# Wisconsin Department of Transportation

**Proposal #43: 8220-00-70, WISC 2024040**  
**Gilman - Medford**  
**Black River Bridge B-60-0001**  
**STH 64**  
**Taylor County**

This is Addendum No. 01, which provides for the following:

**ADDENDUM NO. 01**

Addendum No. 01  
ID 8220-00-70  
Revised Sheet 3  
October 30, 2023

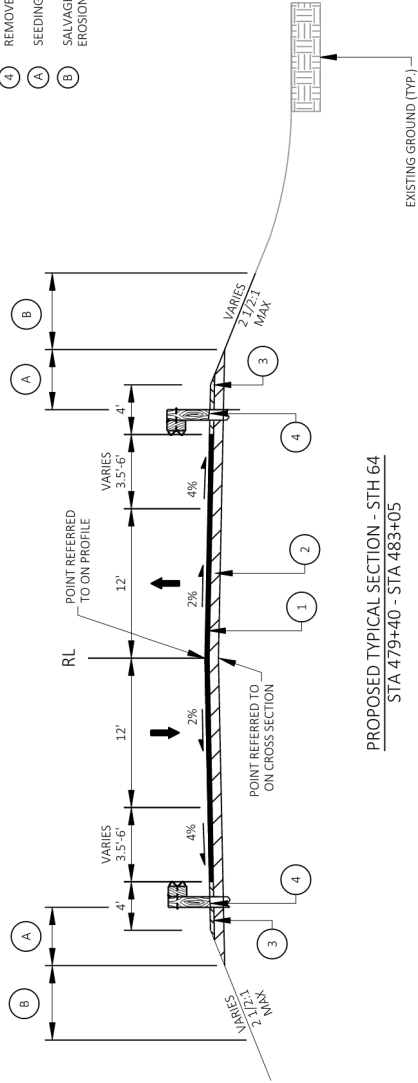
<b>Revised Plan Sheets</b>	
<b>Plan Sheet</b>	<b>Plan Sheet Title (brief description of changes to sheet)</b>
3	Typical Sections (Replaced 4 MT 58-34 S with Asphaltic Surface)
11	Miscellaneous Quantities (switched bid item for Asphaltic Surface)

- LEGEND
- ① ASPHALTIC SURFACE, 7-INCH LOWER, 2 1/2-INCH, (4MT 58-345) UPPER, 2-INCH, (4MT 58-345)
  - ② BASE AGGREGATE DENSE 1 1/4-INCH, 12-INCH
  - ③ BASE AGGREGATE DENSE 3/4-INCH
  - ④ REMOVE, SALVAGE, AND REINSTALL GUARDRAIL
  - Ⓐ SEEDING MIXTURE NO. 30 & FERTILIZER TYPE B
  - Ⓑ SALVAGED TOPSOIL, SEEDING MIXTURE NO. 30, FERTILIZER TYPE B & EROSION MAT URBAN CLASS I TYPE B
